## License to Operate On-Site Sewage Treatment and Disposal Facility

Issued This Date: 09/28/2022 Permit Number: 113268

Location Description: 172 GRANITE RD  
SPRING BRANCH, TX 78070

RE: 172 Granite Rd, Cypress Cove, Section 9, Lot 610

OWNER: AAID CONSTRUCTION, LLC.		DRAWN BY: EJS III	
STREET ADDRESS: 172 GRANITE ROAD			
LEGAL DESC: CYPRESS COVE	UNIT/SECTION/PHASE: 9	BLOCK: 9	LOT: 610
PREPARED BY: GREG W. JOHNSON, P.E. F#002585	SCALE: 1"=20'	DATE: 8/5/2021	REVISED:

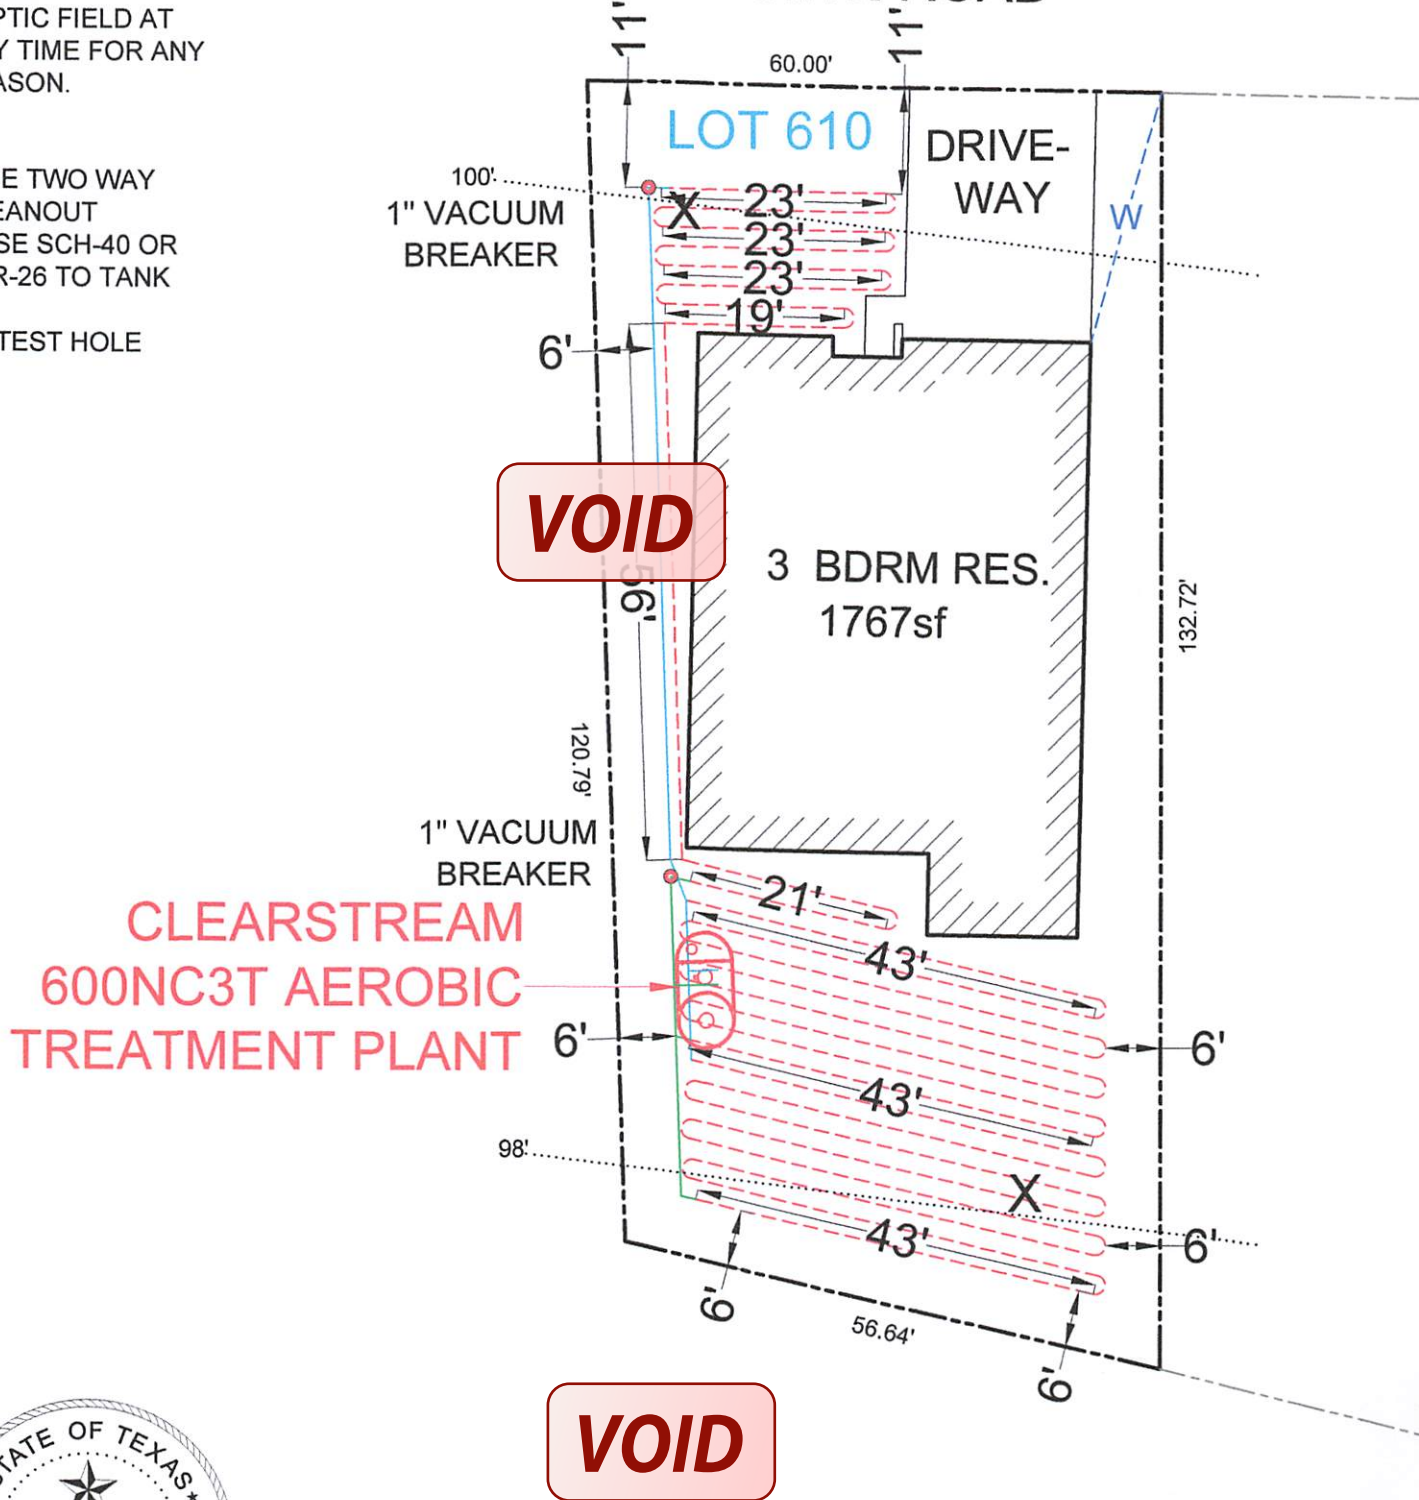
We received planning materials for the referenced permit application on 9/16/21 and found those planning materials to be deficient. In order to continue processing this permit, we need the following:

- ✓ 1. Show the location of the septic line from the structure to the tank including the location of the cleanout.
2. Revise accordingly and resubmit.
